Duke Power
Nuclear Design Methodology Using
CASMO-4 / SIMULATE-3 MOX
DPC-NE-1005-NP-A
Revision 0

**SUBJECT: FINAL SAFETY EVALUATION FOR DUKE TOPICAL REPORT
DPC-NE-1005P, "NUCLEAR DESIGN METHODOLOGY USING
CASMO-4/SIMULATE-3 MOX"**

Subject: Catawba Nuclear Station Units 1 and 2; Docket Nos. 50-413, 50-414
McGuire Nuclear Station Units 1 and 2; Docket Nos. 50-369, 50-370
Response to Request for Additional Information - Topical Report DPC-NE-1005P, Revision 0, *Nuclear Design Methodology Using CASMO-4/ SIMULATE-3 MOX* (Proprietary)

Figure 3.4 Plutonium Fissions – Fraction of Total Fissions

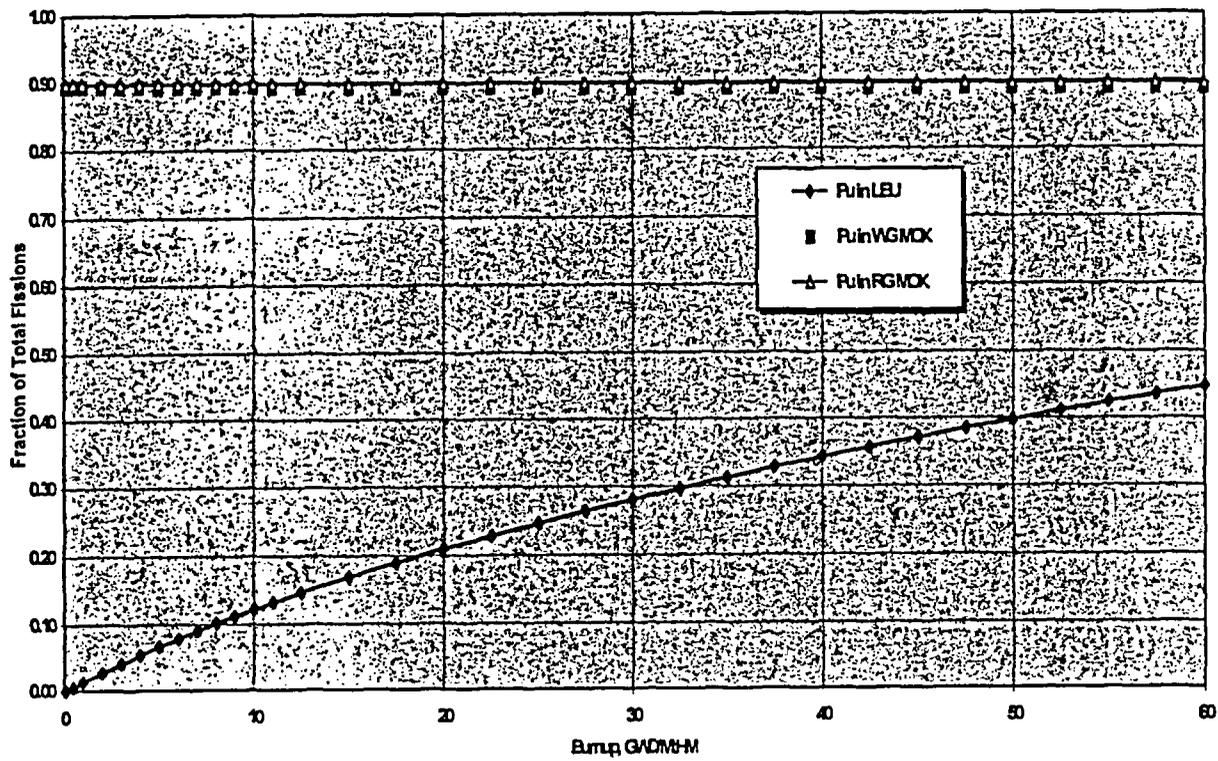
23. Please provide a discussion of the differences between weapons-grade and reactor-grade MOX fuel. Provide a specific basis for why the data for reactor-grade MOX fuel is adequate for weapons-grade MOX fuel and quantify the differences between the fuel types.

As a result of the changes described above, the source of fissions changes markedly with burnup for LEU fuel. However, both RG MOX and WG MOX fuel have little thermally fissionable uranium, so the fissions in both MOX fuel types are approximately 90% plutonium at any burnup. This effect is shown on Figure 3.4.

Figure 4-17 EPICURE Critical Experiments – General Layout

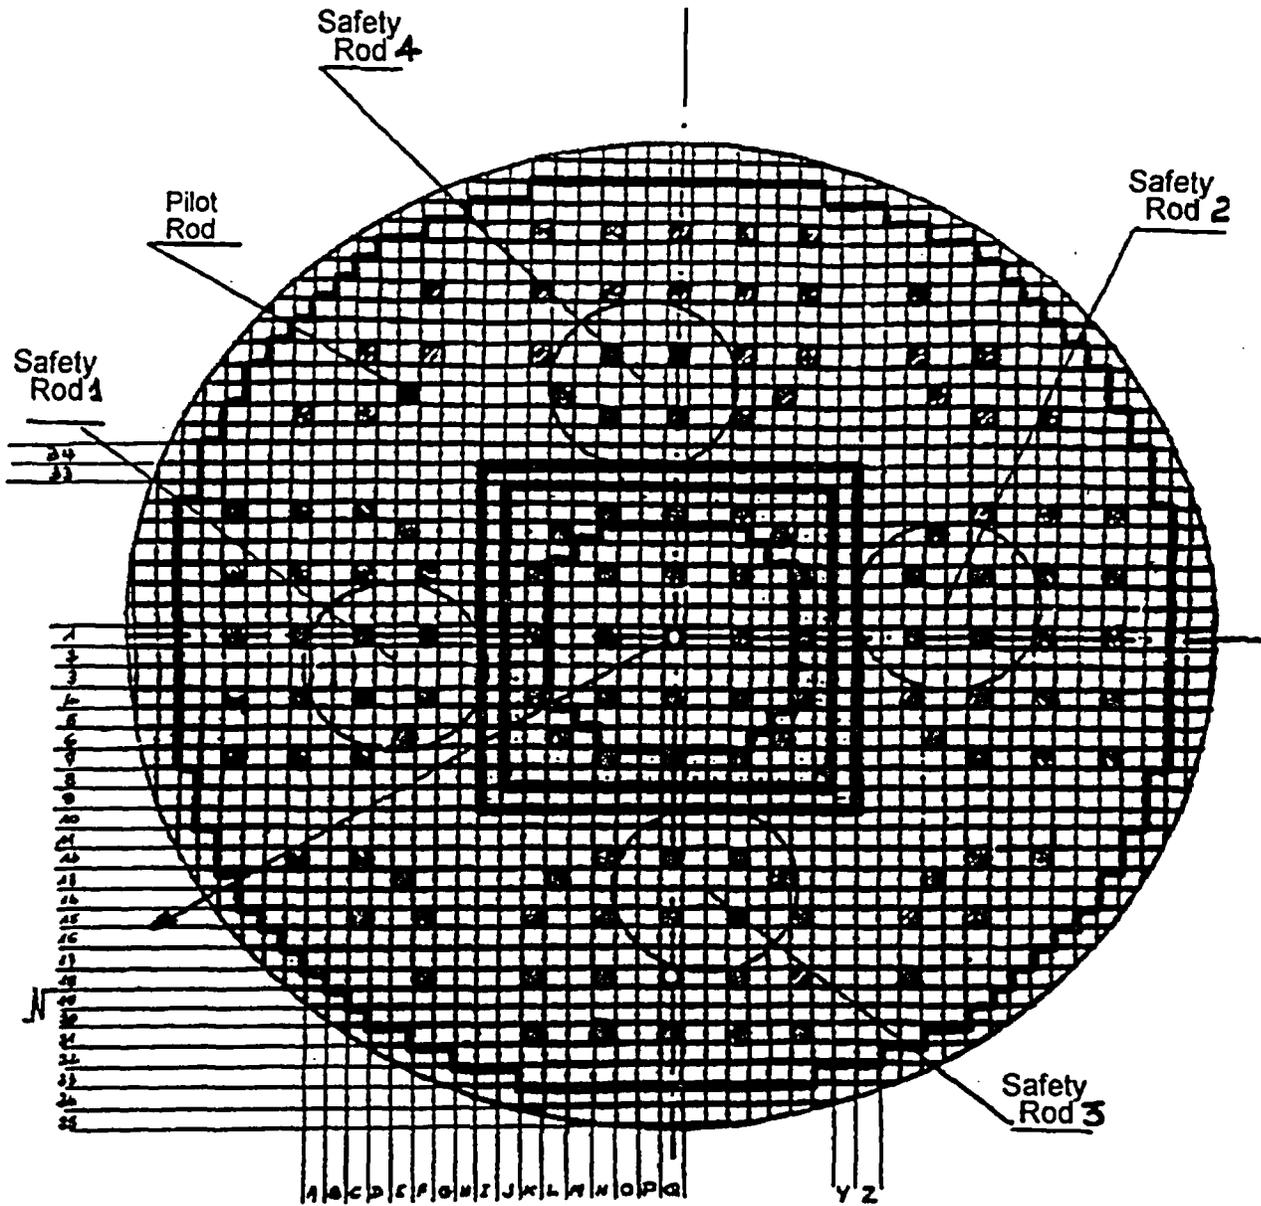
21. The second paragraph on page 4-7 discusses the EPICURE experiments. It is mentioned that the experiments used a fuel pin layout that is comparable to the Duke MOX fuel assembly layout. Please provide additional details to support this statement.

The statement refers specifically to the UMZONE No BP, UMZONE B₄C, and UMZONE AIC experiments, which are illustrated in Figures 4-18, 4-19 and 4-20. As depicted in Figure 4-17, the MOX region is a 17 x 17 layout with 24 guide tubes and one instrument tube in the central region of the EPICURE core, a configuration virtually identical to that of a McGuire/Catawba 17 x 17 fuel assembly. The EPICURE experiments have a pin pitch of 1.26 cm which is nearly identical to that of the planned MOX fuel design (1.265 cm). The MOX fuel region consists of three concentrations of MOX fuel with the lowest concentration on the outside of the lattice and the highest MOX concentration in the central part of the lattice, which is the same configuration as that in the planned MOX fuel assembly design. Also, the MOX fuel lattice in these experiments is surrounded by a buffer region of LEU fuel with a Westinghouse 17 x 17 type pin layout, which is typical of the condition that would exist in a mixed MOX/LEU fuel core. Table 4-1 provides additional comparison information for the fuel assembly design.
